Open Procedure: Cyclotron, Hotcells, Switching system, Shielded Laminar Air Flow workbench (LAF)for Tc-99m Generators

Appendix 5: Questions & Answers (Q&A) form

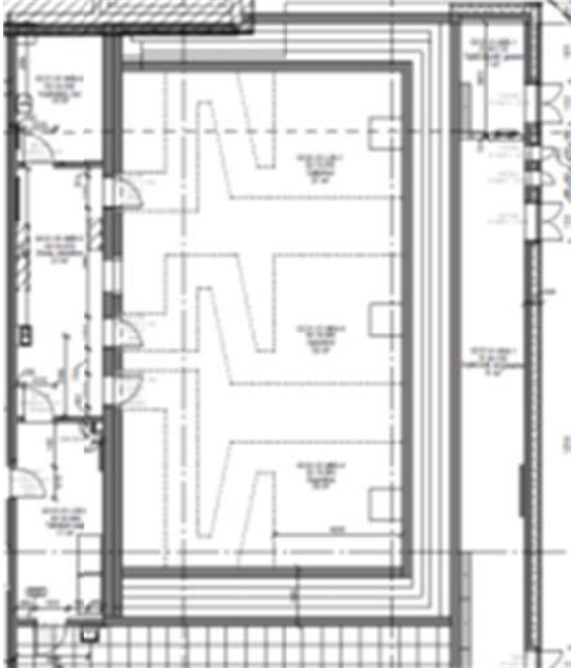
<p>there is a new ESPD form available? The actual one on your website is .xml file that stays unreadable.</p>	
62.	Shielding and radioprotection responsibility (lot 1)		<p>Who is taking the responsibility for the radioprotection and shielding calculations?</p> <p>Who is responsible of the design for wall thickness, maze design, transfer line shielding and so on?</p> <p>Is it the tenderer or the local Radiation Safety Officer?</p> <p>We are assuming that we provide only a layout for implantation into the proposed shape of maze/vault (including precise target location) and that we</p>	<p>It is the responsibility of the Contracting Authority to undertake the necessary dialog with the Danish Radiation Protection Authority to ensure final approval of the installation.</p> <p>It is the tenderers responsibility that the proposed layout for the installation fulfills the limitations on dose rates (1 and 5 $\mu\text{Sv/h}$) as specified in the requirement specification, appendix 1a. The dose rate limit at the roof above the cyclotron bunker is 5 $\mu\text{Sv/h}$. The roof is expected to be constructed as 1800 mm normal concrete.</p>

<p>provide the neutron and gamma source term of the cyclotron/target. Then shielding arrangements will be performed by the customer to take into consideration surrounding machines and other hypothesis, could you confirm?</p> <p>During the visit, it has been said that occupancy factors could be considered as low for a lot of surrounding areas (e.g. roof above the vaults, gas room,...). In any case, if tenderer is responsible for the shielding we should know these occupancy factors or the limit dose rate in each surrounding</p>	
--	--	--	---	--

location and expected usage of the machine (amount of runs per day or week, activity produced, type of produced isotope, type of irradiation (Single/Dual); and we should know this information for the entire expected life time of the equipment (approx. 20years)) in order to work on the same hypothesis for all tenderers.	
--	--	--	--	--
